MEMORANDUM FOR: Docket File No. 40-8768

SUBJECT: SAFETY EVALUATION REPORT (SER) FOR THE RENEWAL OF  
THE SEQUOYAH FUELS CORPORATION Q-SAND/O-SAND R&D  
ISL PROJECT

SAFETY EVALUATION REPORT  
FOR RENEWAL OF  
SOURCE MATERIAL LICENSE  
FOR  
SEQUOYAH FUELS CORPORATION  
Q-SAND/O-SAND R&D ISL PROJECT  
CONVERSE COUNTY, WYOMING  
DOCKET NO. 40-8768  
LICENSE NO. SUA-1387

Figure 2.2.01 - Schematic Flow Diagram of Process Plant

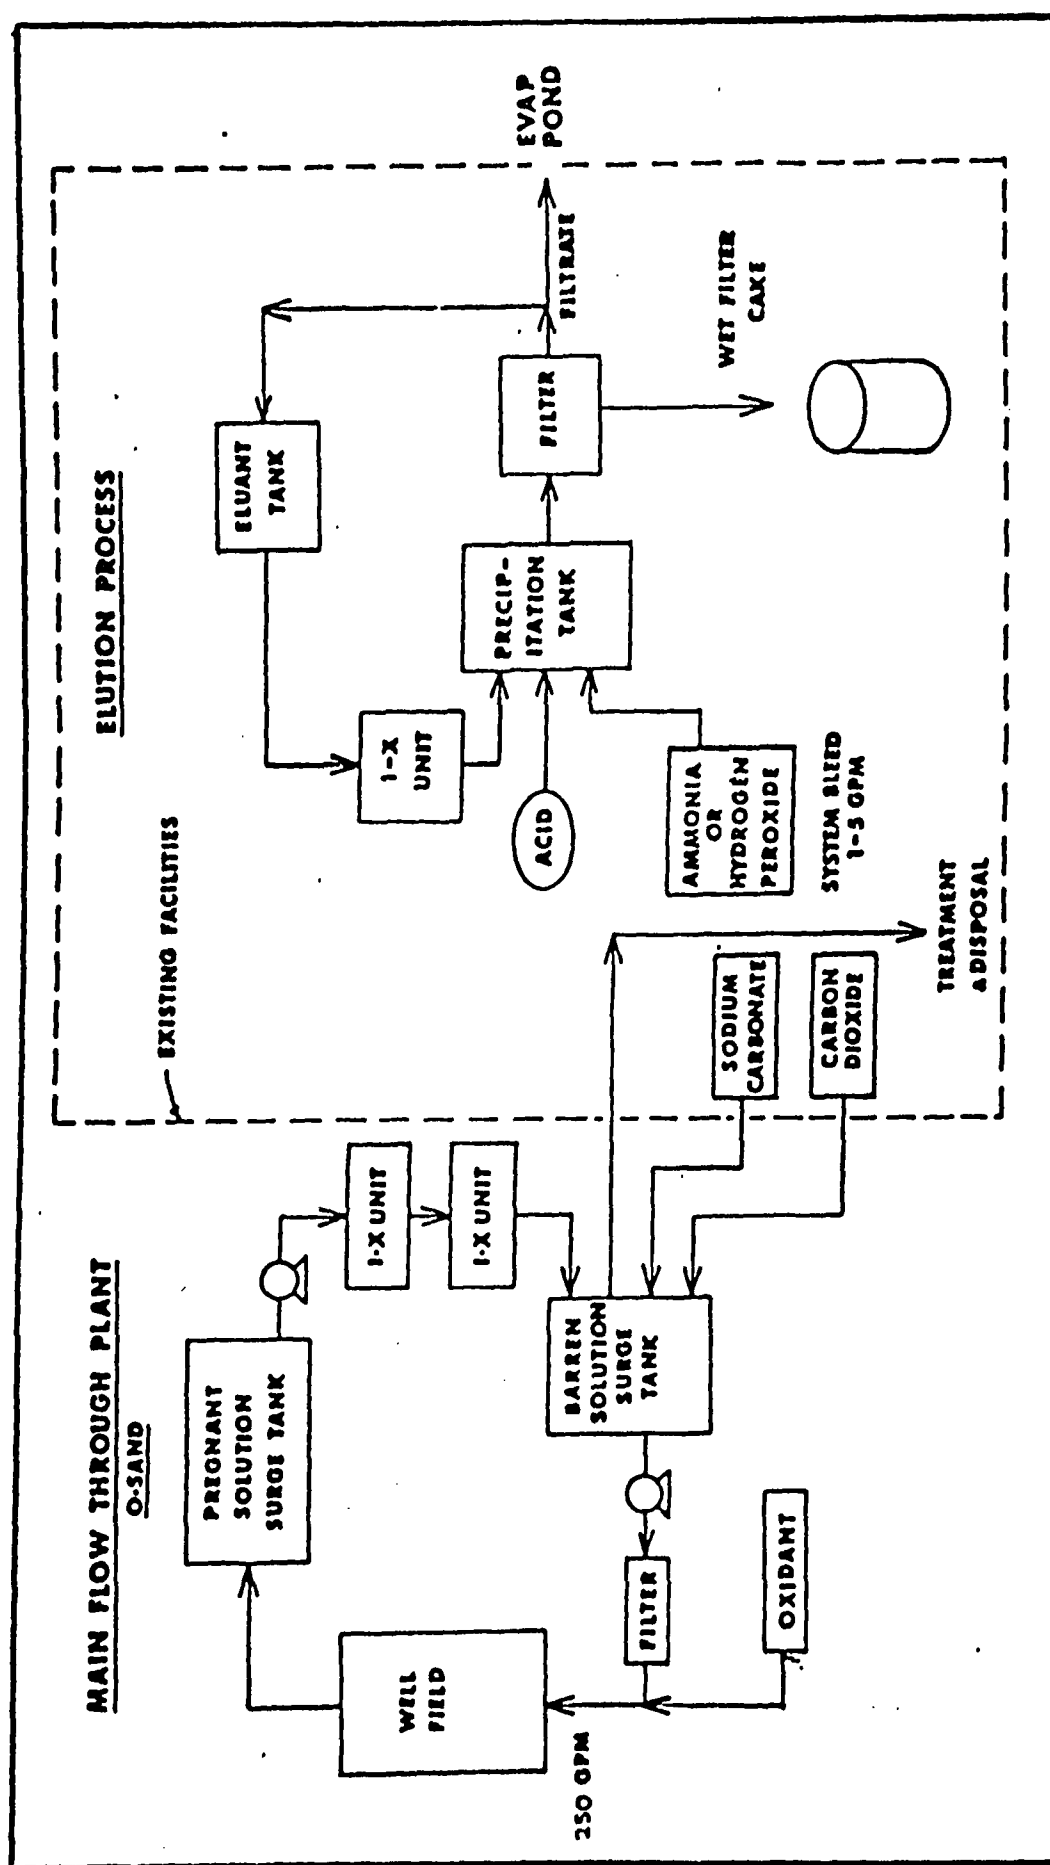
loaded on the column resins, is stripped (eluted) with a strong sodium chloride or hydrochloric acid solution. In this stripping process, the chloride ions replace the uranyl carbonate complexes on the resin, forming a concentrated uranium bearing solution that is then pumped to the precipitation circuit. Following the addition of hydrochloric acid, sodium hydroxide, and hydrogen peroxide, the uranium is precipitated in the form of uranium peroxide ( $UO_4$ ). The precipitate is partially dewatered by use of a filter press and shipped in slurry form to a uranium conversion facility. All shipments will be made in compliance with applicable regulations. A schematic flow diagram of the recovery plant is shown in Figure 2.2.01.

To assure that the process circuit stays in its present configuration and is not changed without adequate health and safety considerations, the licensee will be prohibited by license condition from making major changes in the process circuit without prior approval of the corporate radiation safety officer (RSO) and the USNRC.

1. Any major changes in the process circuit, as illustrated and described in Figure 1-1 of Appendix XI of the licensee's June 15, 1987 submittal shall be reviewed by the RSO and shall be submitted to the USNRC, Uranium Recovery Field Office, for prior approval in the form of a license amendment.

Figure 4.2.01 - Airborne Uranium

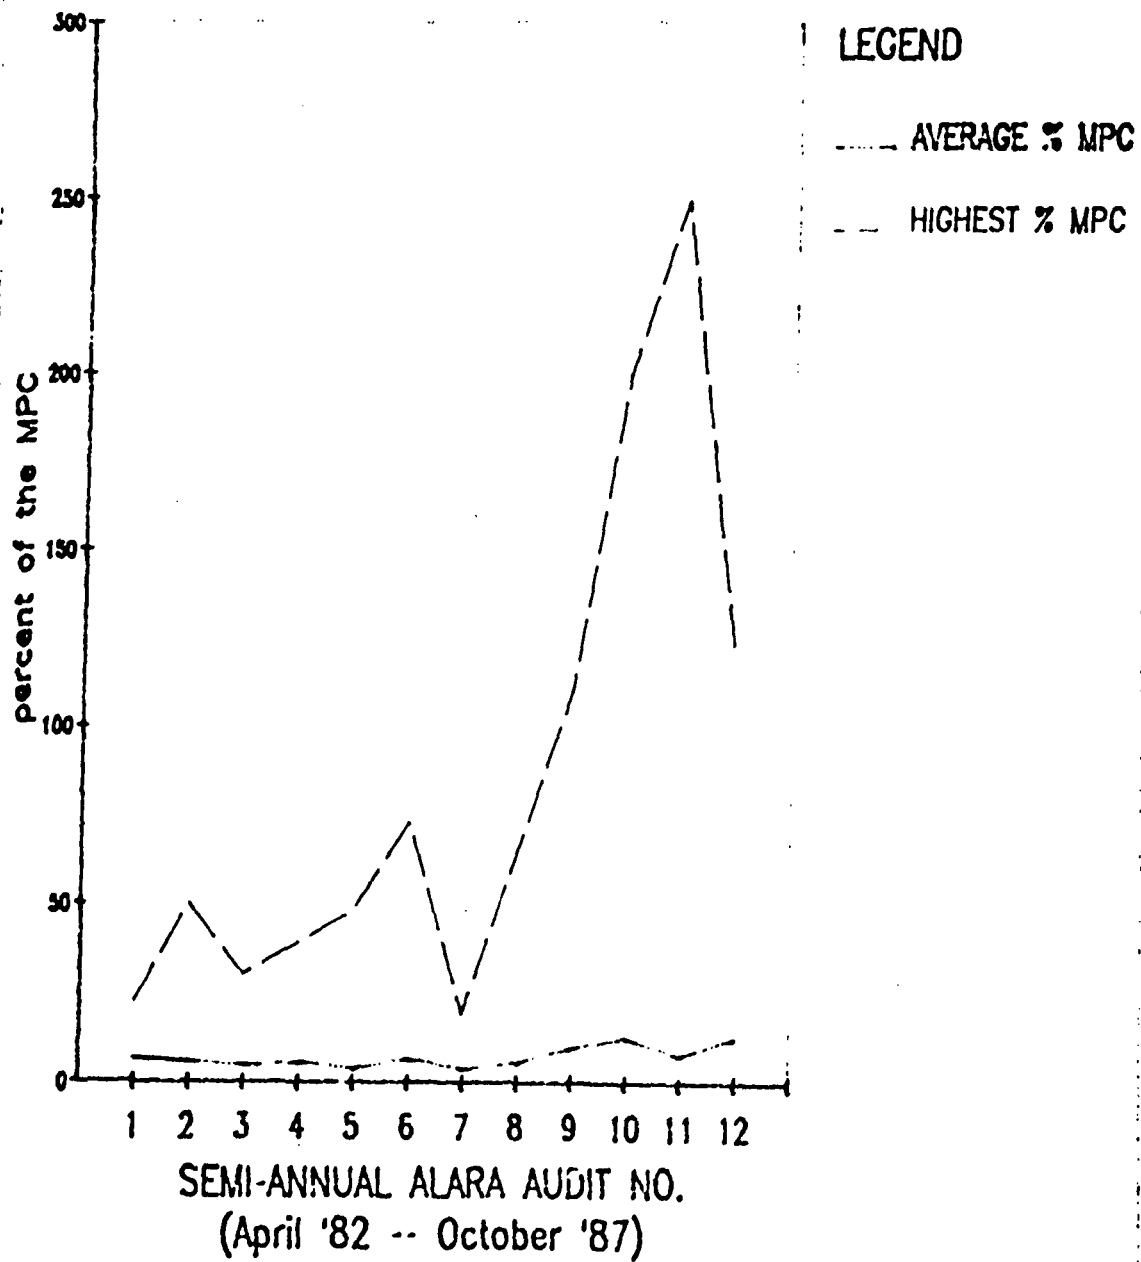
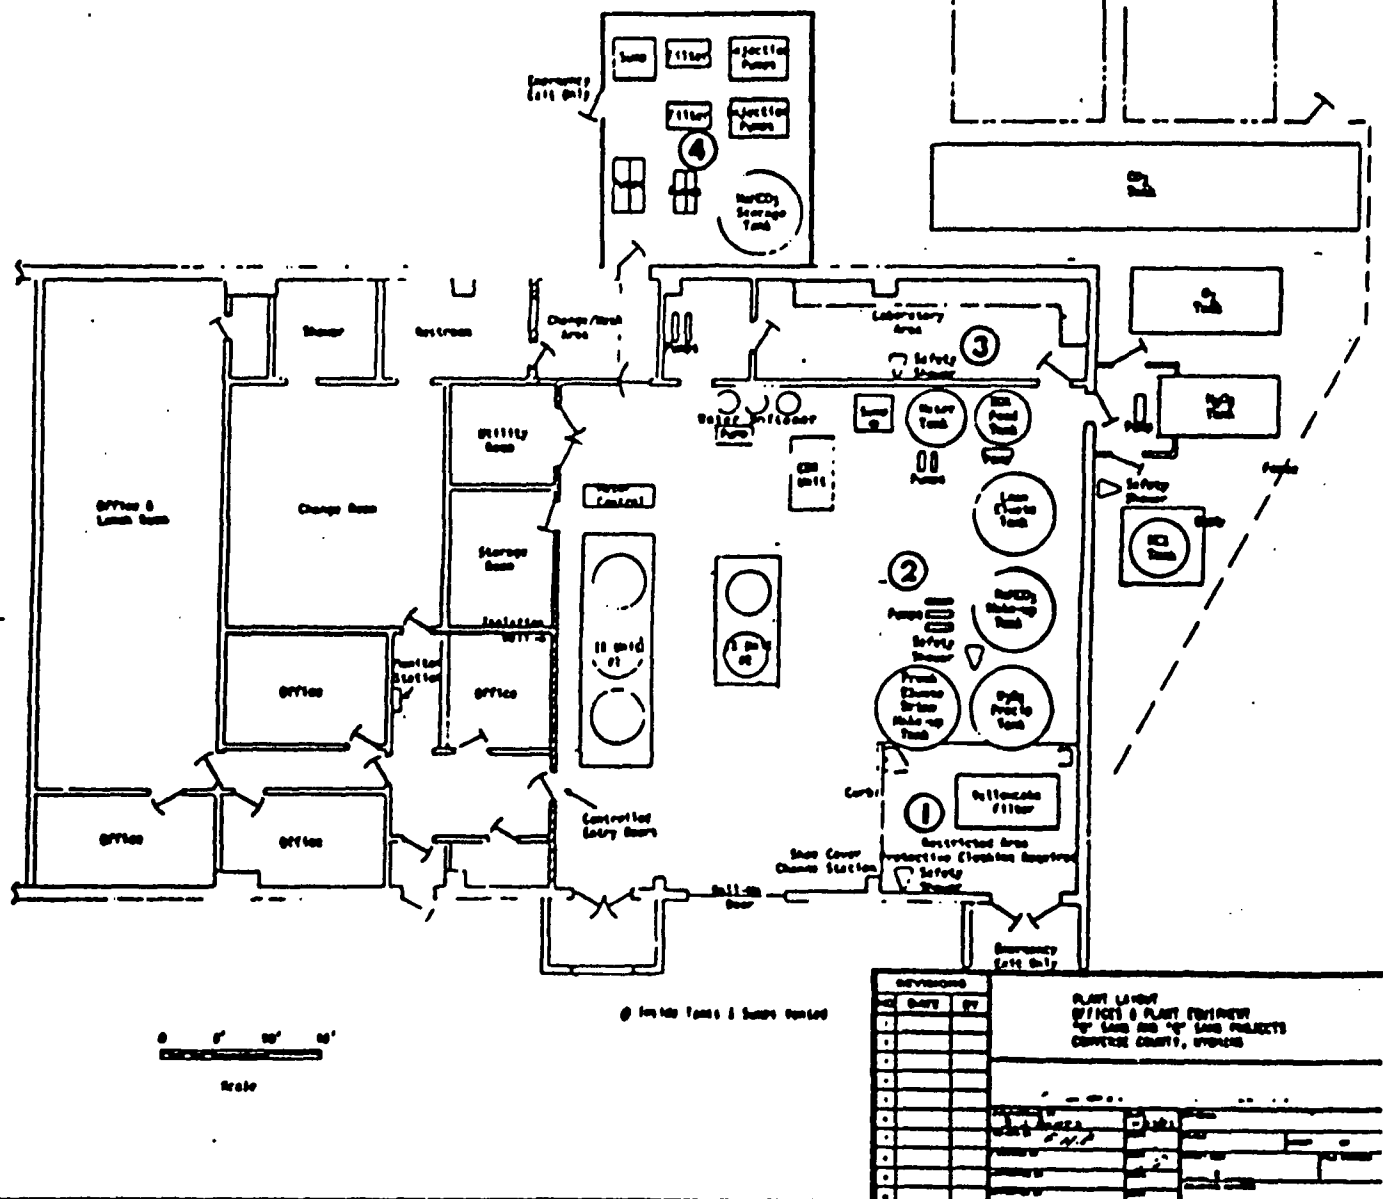
Previous in-plant monitoring for radon progeny indicate that the ventilation systems are efficient in removing these radionuclides from the process building. However, airborne uranium in the yellowcake press area has had high individual values, even though the average values are low. The high individual values have exceeded the MPC during the last four semiannual ALARA audits (see Figure 4.2.01). Historical operational data indicate that airborne uranium in the yellowcake press area has been increasing since 1985 (see Table 4.2.01). The average percent MPC from initiation of operations through 1985, was 4 percent of the MPC. From the end of

1985 through October 1987, the average has increased to 9 percent of the MPC.

Although average airborne uranium concentrations have been increasing, average radon progeny concentrations in the general process area (as measured in the locations specified in Figure 4.2.02) have been decreasing. This trend is shown in Figure 4.2.03. Figure 4.2.04 shows the relationship of the average radon progeny and the highest value for each ALARA audit. Furthermore, time-weighted exposure results are also low (see Table 4.2.01), indicating that the yellowcake press operators are not receiving the exposures. This is most likely due to the limited amount of time operators spend in the yellowcake press area.

In the staff review of SFC's latest ALARA audit, the increasing (and high) airborne uranium concentrations were investigated. Numerous discussions with SFC have resulted in several new commitments by SFC (December 14, 1987 submittal) which the staff believes will reduce the potential for increased airborne uranium uptake by the operators. These commitments will be referenced by license condition and include:

- ° Sample heads of fixed air samplers in the yellowcake area will be no more than 7 feet above the floor when sampling during the press loading and unloading operations.

- ° Air volume meters on the air samplers in the yellowcake press area will be checked against a master meter and recalibrated, if needed, at least once per month for periods when the yellowcake press is being used.

- ° The master meter used for checking the air sample meter in the yellowcake press area will be calibrated at least annually.
- ° An additional airborne uranium sample station will be established near location 2 on Figure X-3 of the application for license renewal, and a sample will be collected at this station at least once per month to include a press loading and unloading cycle for periods when the yellowcake press is being used.

- ° To document that the yellowcake area fixed air samplers are representative of the breathing zone, a 1-month sampling program using both lapel samplers and fixed air samplers will be conducted, and the results will be submitted to NRC within 60 days of completing the test.

- ° Plant operators will be required to wear half masks while unloading the yellowcake press and will be required to wash down the area after the press is unloaded. These programs will be set forth as requirements in SFC's operators manual.
